MOUNT OWEN CONTINUED OPERATIONS PROJECT

Response to Queries Raised by
Agencies Following
Response to Submissions

November 2015

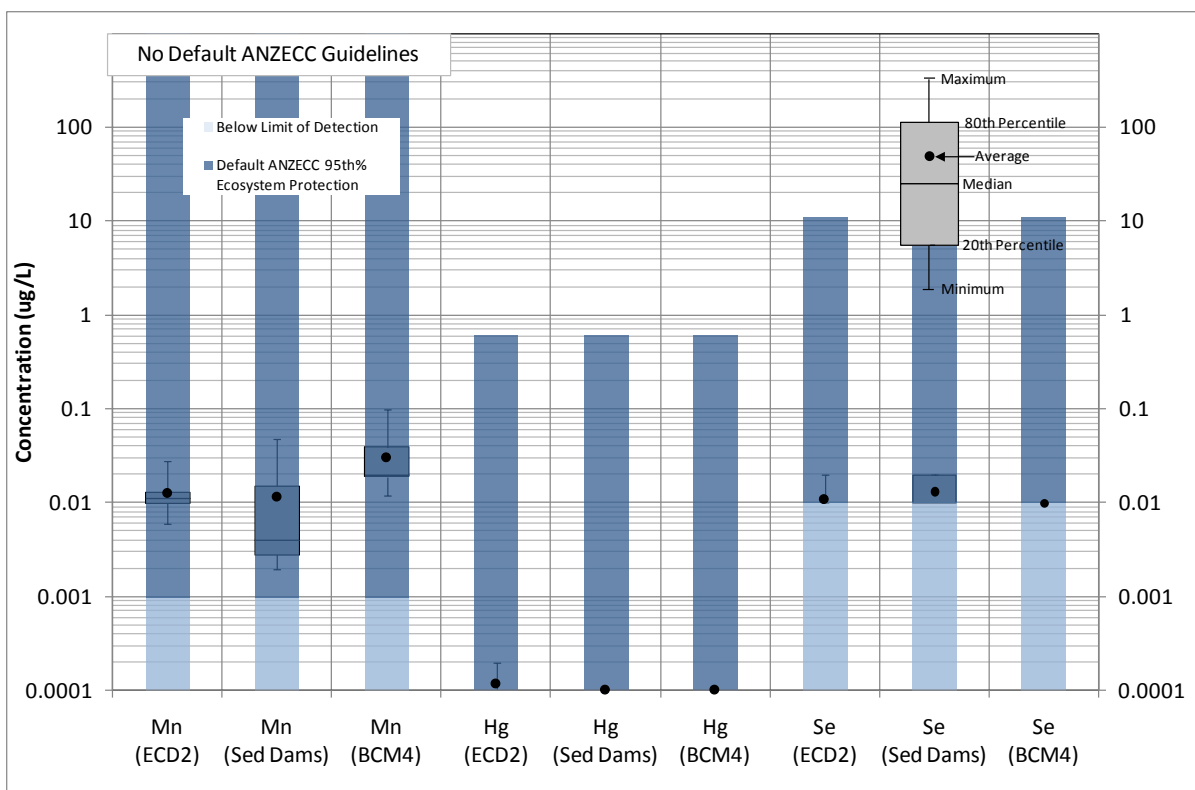
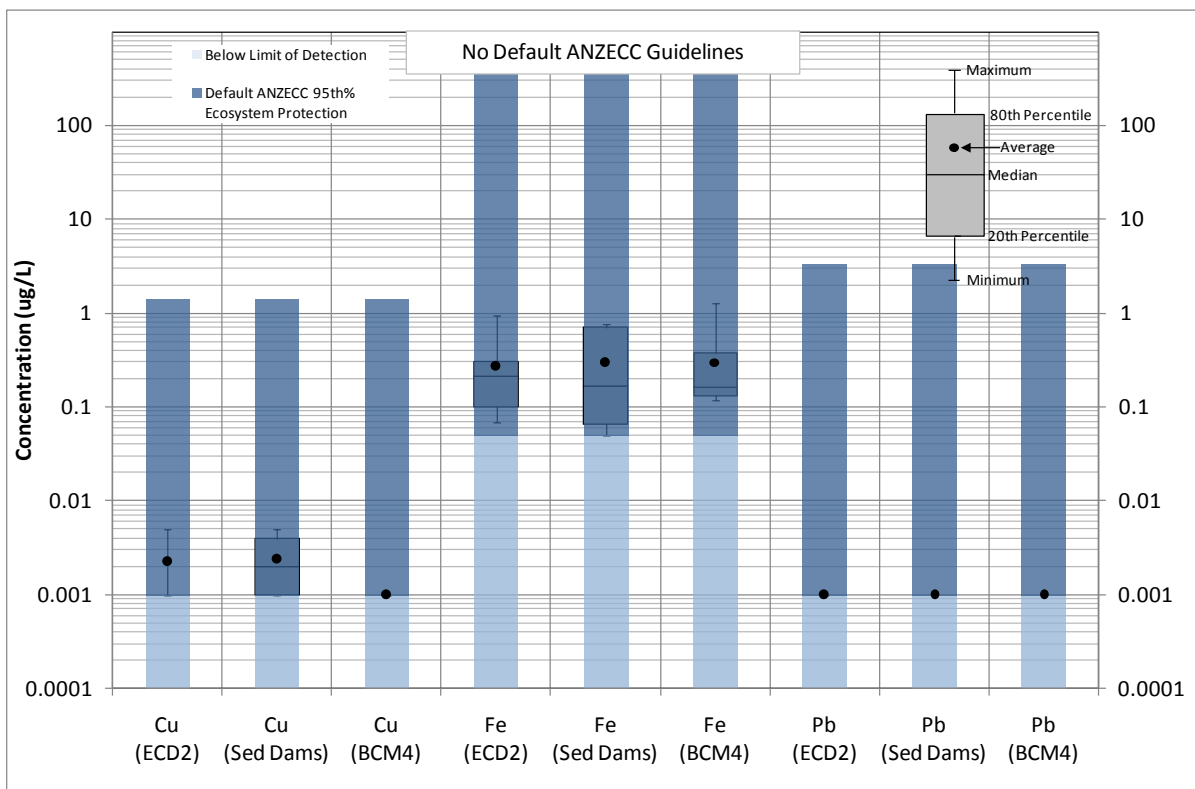
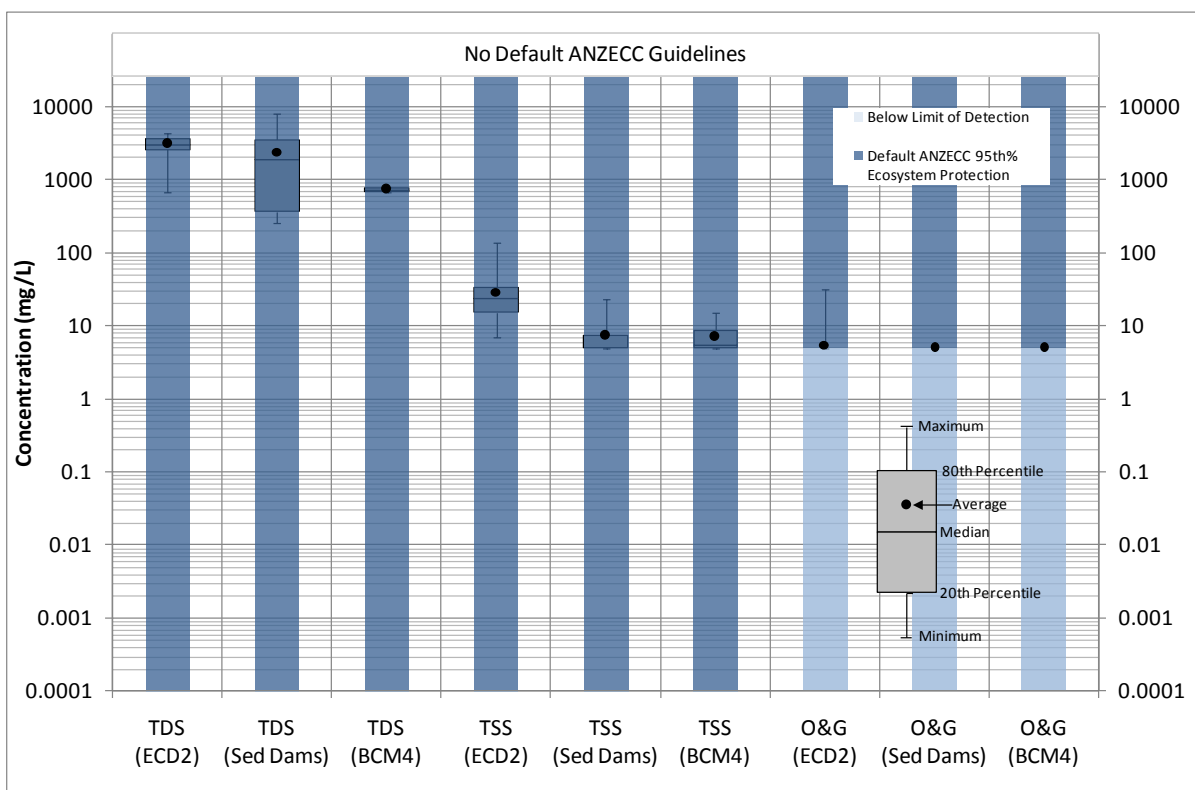
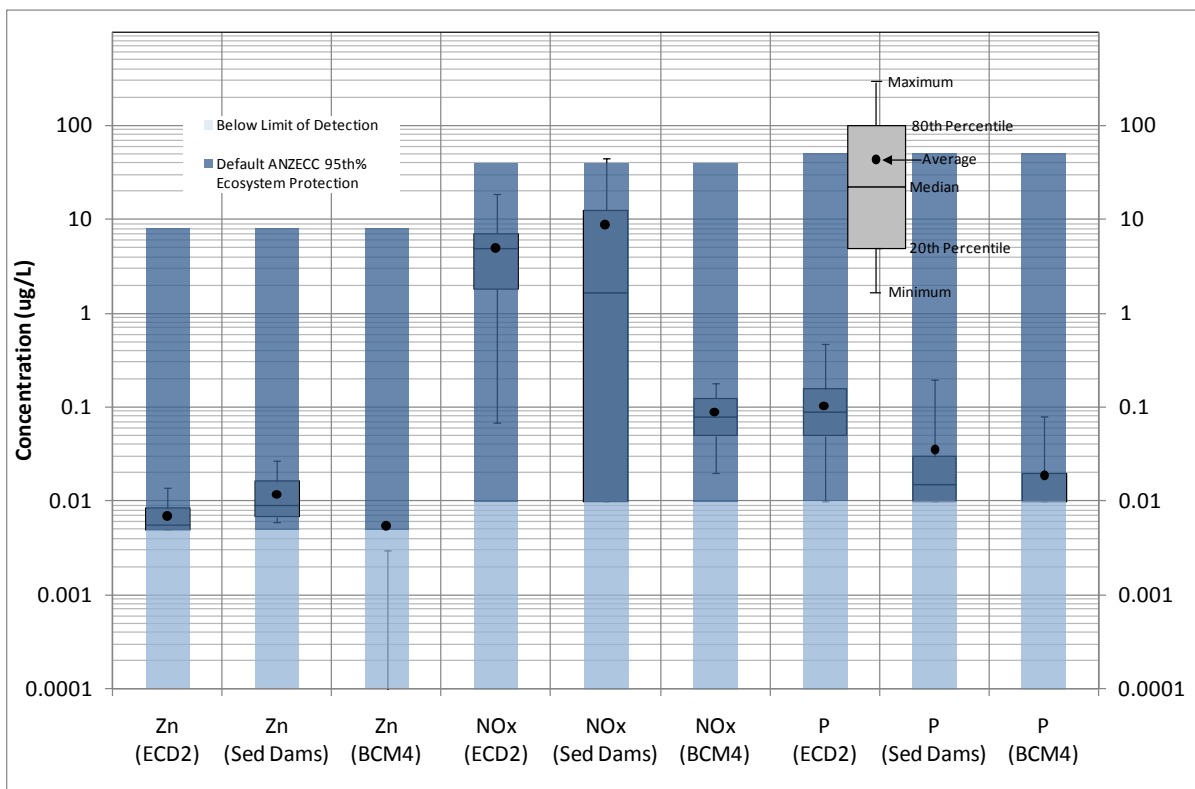
The water quality monitoring data presented under 2.2.5.2 (Report B, RTS) indicates some metal and other parameters appear to be elevated in their concentration including NOx, Mn, Fe and TDS but these have not been discussed. It would be useful to know when this data was collected. In addition, these graphs use the measurement unit mg/L which is inconsistent with ANZECC guidelines use of ug/L-1.

The error noted was the result of an incorrect labelling of axis units. The graphs have been updated and provided below.

The sampling of ECD2 (Mine Water Dam) and BCM4 (Bowmans Creek) used in the graphs was taken from 12 sampling results over the period 20 March 2014 to 18 August 2014 except for EC, NOx, pH, P, TDS and TSS in the ECD2 results which are from 53 samples taken over the period 5 January 2010 to 18 August 2014.

FIGURE B

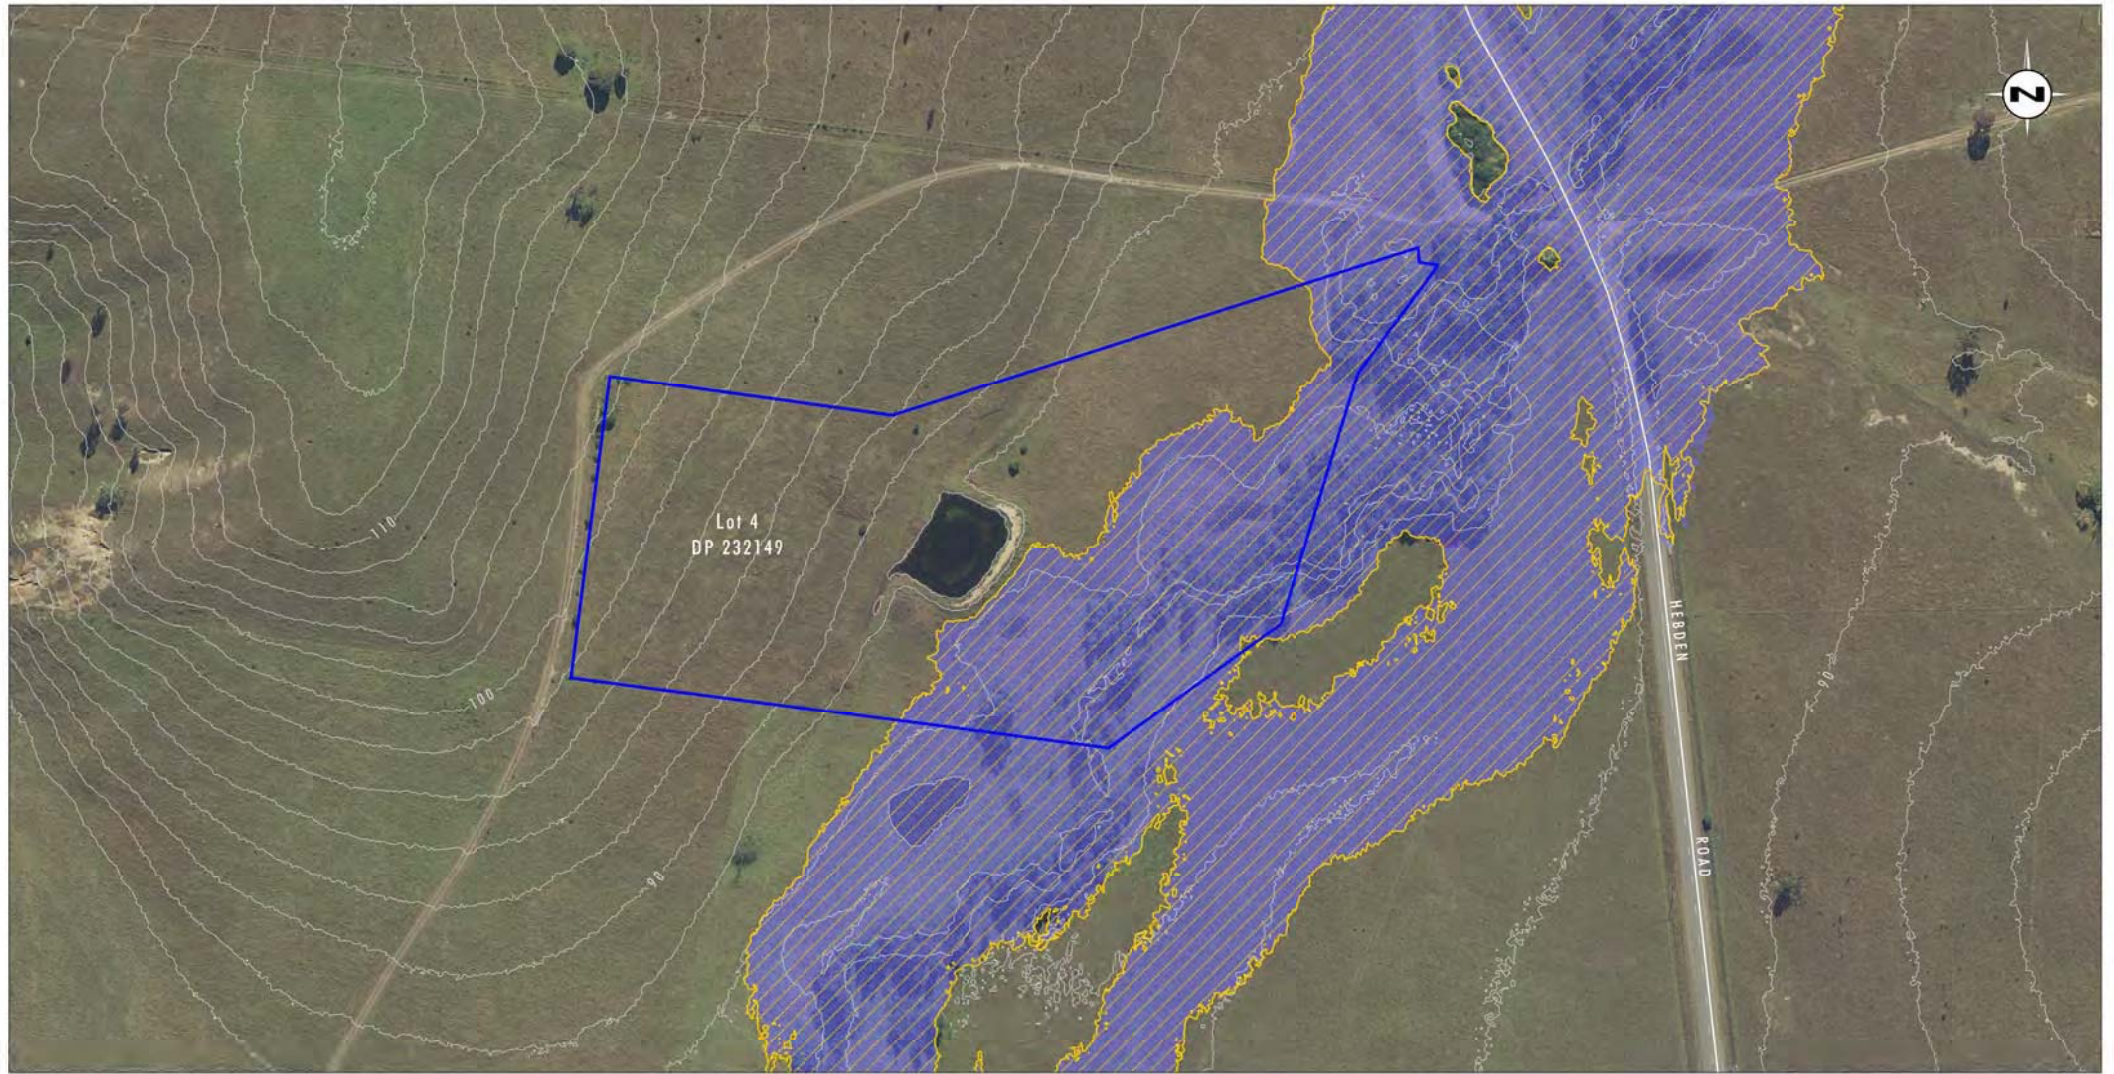
Hebden Road is a public road. Any adverse change to existing depth or period of inundation of this roadway provides an increased risk to road users and the emergency services in flood events. The proponent is required to demonstrate no additional adverse effects on public infrastructure as a result of the development.

The predicted change in modelled flood extent during the 1 per cent AEP storm event at Location 1 is shown on **Figure B**. The figure indicates that the change in the extent of flooding from the approved final landform to the proposed final landform is negligible.

As is shown on **Figure B** and in the data presented above the flooding impacts at Location 1 will result in a small additional flood extent with negligible to minor increases in flood depths ranging between 0.01 metres to 0.15 metres and minor increases in flooding durations of approximately 55 minutes. To put this increase in context, the modelled results indicate that the property would experience flooding for durations ranging between approximately 15 hours for the 10 per cent AEP storm event to approximately 20 hours for the 1 per cent AEP storm event in relation to the currently approved final landform.

FIGURE 4.2
 Conceptual Surface
 Water Management
 Year 1

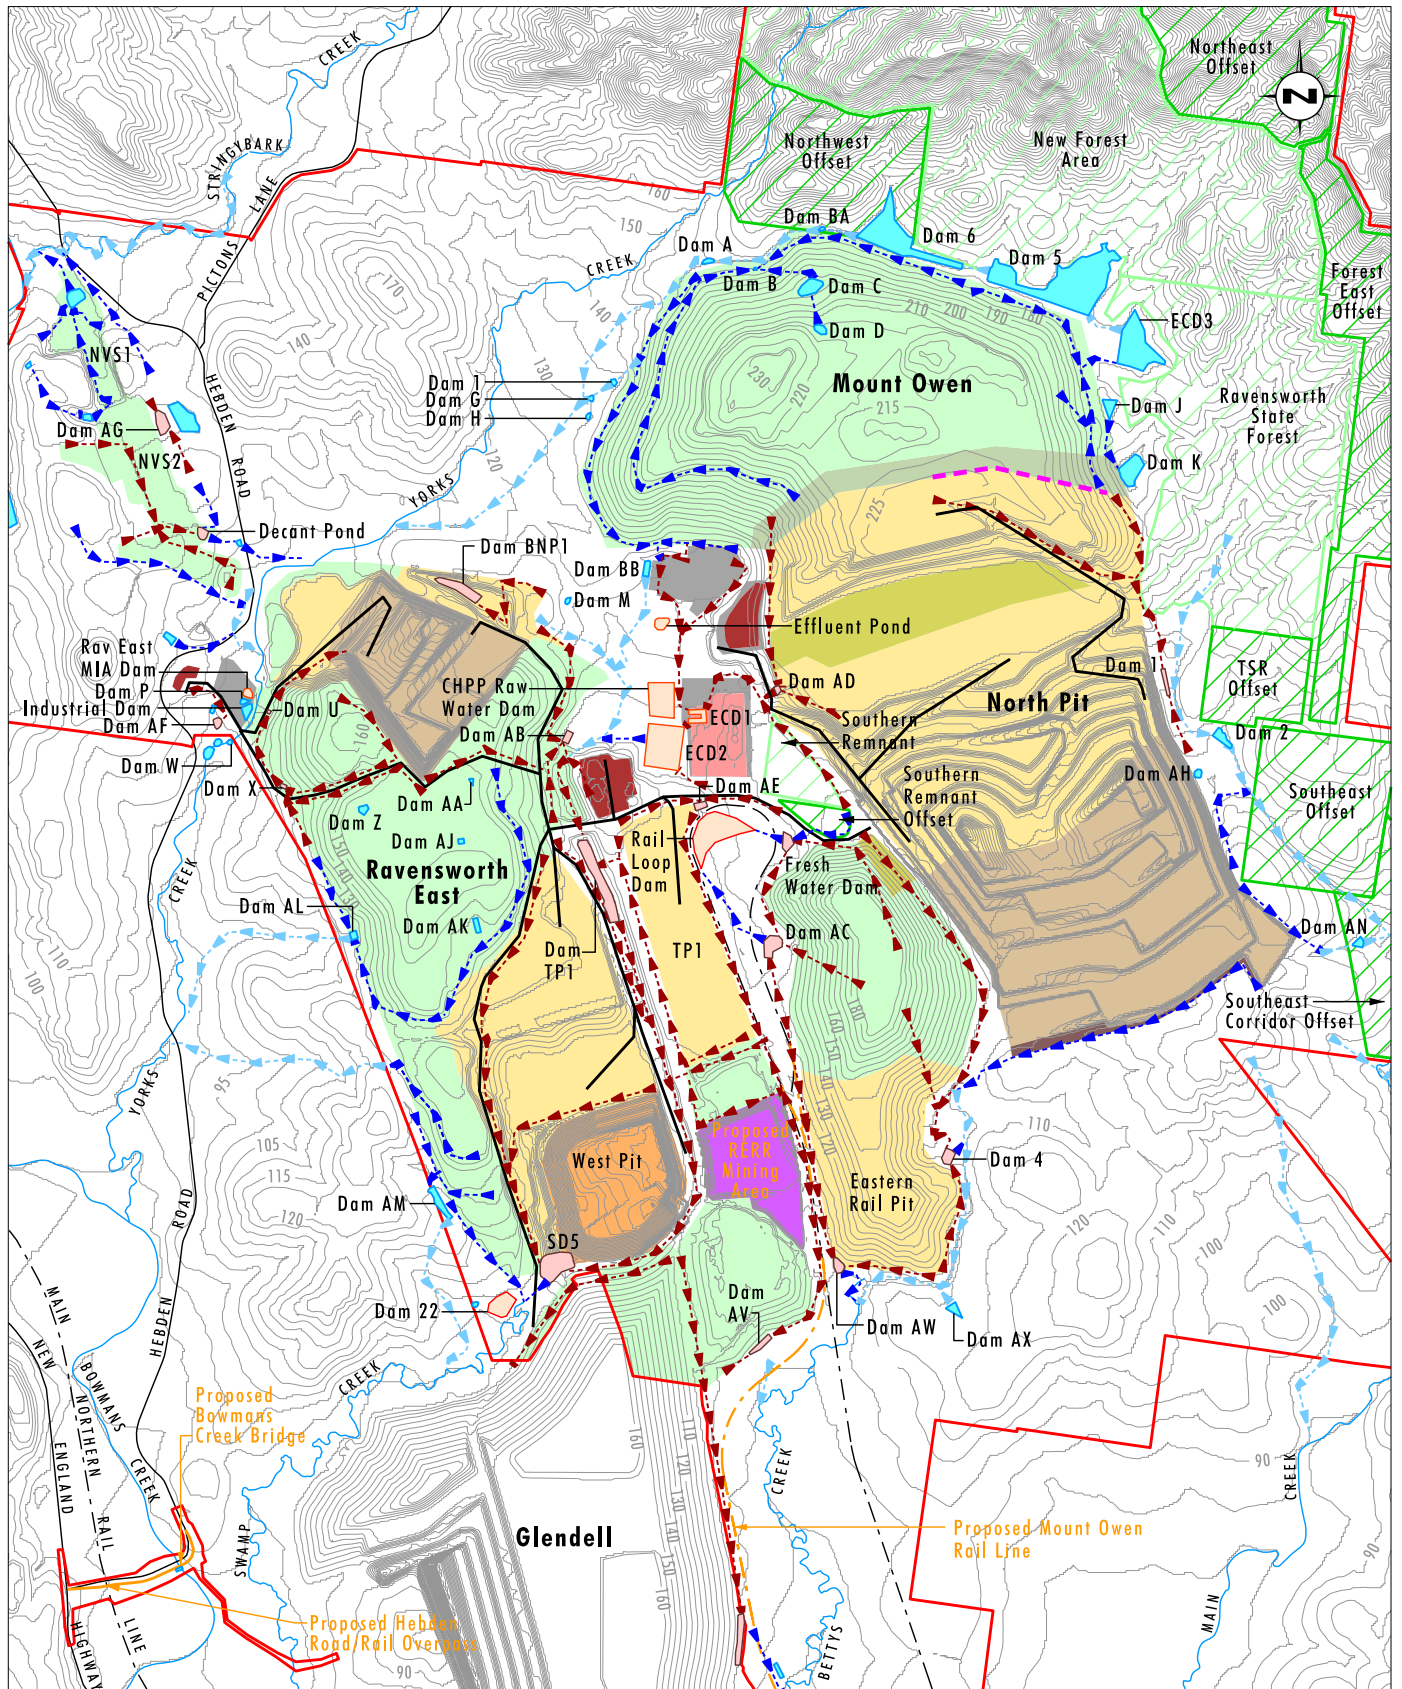
- ***In Year 1 of the project, there are clean water diversions north-west of Ravensworth East into Dam X (as shown in Figure 4.2 of the EIS), which is a dirty water dam. Further explanation of this clean water capture in dirty water dams is required.***

- ***In Year 1 of the project there are clean water diversions into dam AG (as shown in Figure 4.2 of the EIS), which is a dirty water dam. Further explanation of this clean water capture in dirty water dams is required.***

The rehabilitated areas shown on Figures 4.2, 4.3 and 4.4 to the south-east of the Freshwater Dam have been planted but are still in a rehabilitation establishment phase. Runoff from this area is not predicted to be of sufficient quality to discharge to the environment until closure. These flowpaths have been updated to be shown as dirty water drains on the figures.

This area, while planted, is still in a rehabilitation establishment phase and runoff from this area is not predicted to be of sufficient quality to discharge to the environment until closure.

This flowpath has been updated to be shown as a dirty water drain in Figures 4.2 and 4.4 in the Surface Water Assessment. The characterisation of the catchment as being part of the water management system in Figures 4.6, 4.7 and 4.8 of the RTS Report A is correct.

This flowpath has been updated to be shown as a dirty water drain in Figure 4.2 as it manages runoff from rehabilitated areas which, while planted, are still in establishment phase. Runoff from this area is not predicted to be of sufficient quality to release to the environment until approximately Year 5 of the Project. The characterisation of the catchment as being part of the water management system in Figure 4.6 of the RTS Report A is correct.

Updated water management **Figures 4.2 to 4.4** reflecting the above are enclosed with this response. There are no changes to Figures 4.6 to 4.8 in the RTS Report A.
